**Re: Glen Burnie Heights
Block PP, Lots 36-37
Variance Application**

SHEET 1 OF 1 VARIANCE PLAN

GLEN BURNIE HEIGHTS Section PP, Lots 36-37

CONFIRMATION OF PRE-FILE

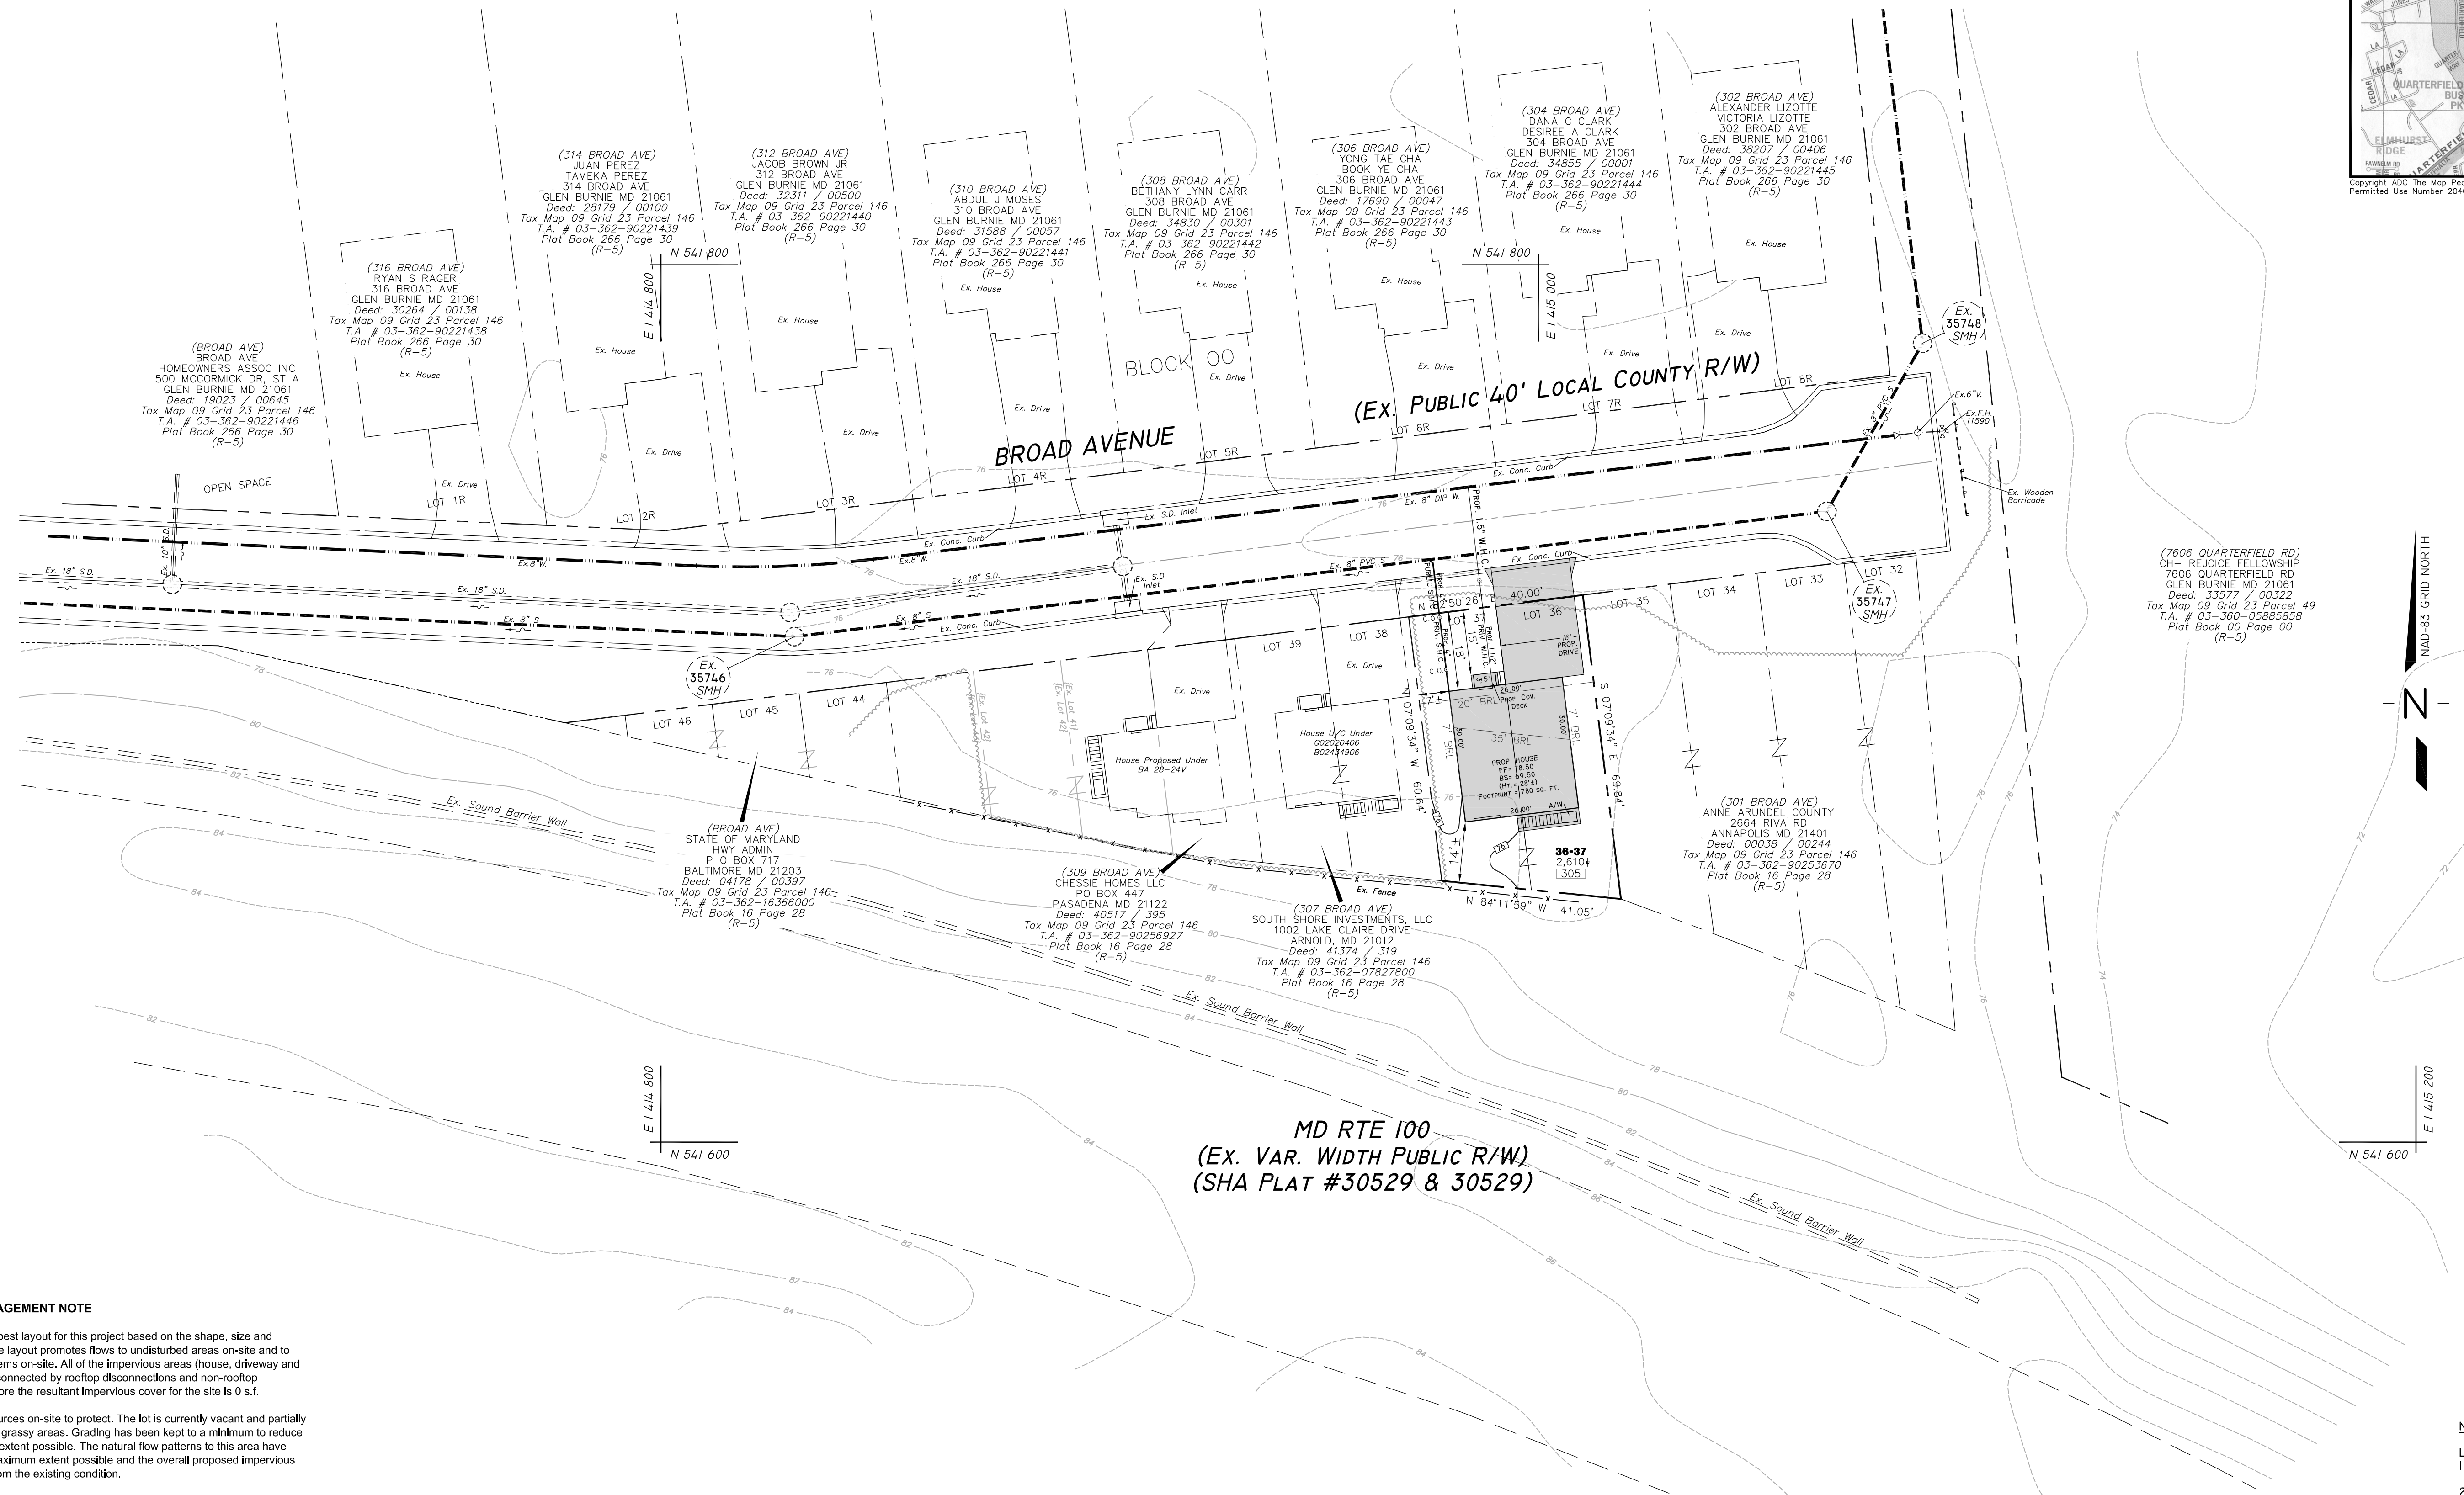
1. Revise the Letter of Explanation and the Administrative Site Plan to reflect the current bulk regulations.
2. Revise the Administrative Site Plan to indicate the distance from the proposed covered porch to the front property line to clarify the relief needed.

3. The applicant had been granted zoning variances for dwellings at 307 Broad Ave (BA 29-24V / 2024-0125-V) and 309 Broad Ave (BA 28-24V / 2024-0124-V) where they argued those dwellings (approved with footprint areas of 572sqft or less) were the minimum necessary. Those variances demonstrate that a smaller dwelling is feasible, which would reduce the relief needed on the subject property.

4. The applicant is encouraged to provide floor plans and/or architectural elevations (front, side and rear) to assist in the evaluation of any requested variance.

1. Note there is a required 455-foot setback from the site's property line to the edge of mainline pavement of

MD-100. A Modification for Article 17-6-110 will be required at Grading Permit.

2. Alternate methods of stormwater management may be required if the WQv cannot be met by Rooftop and Non-Rooftop Disconnections due to the size of the lot.
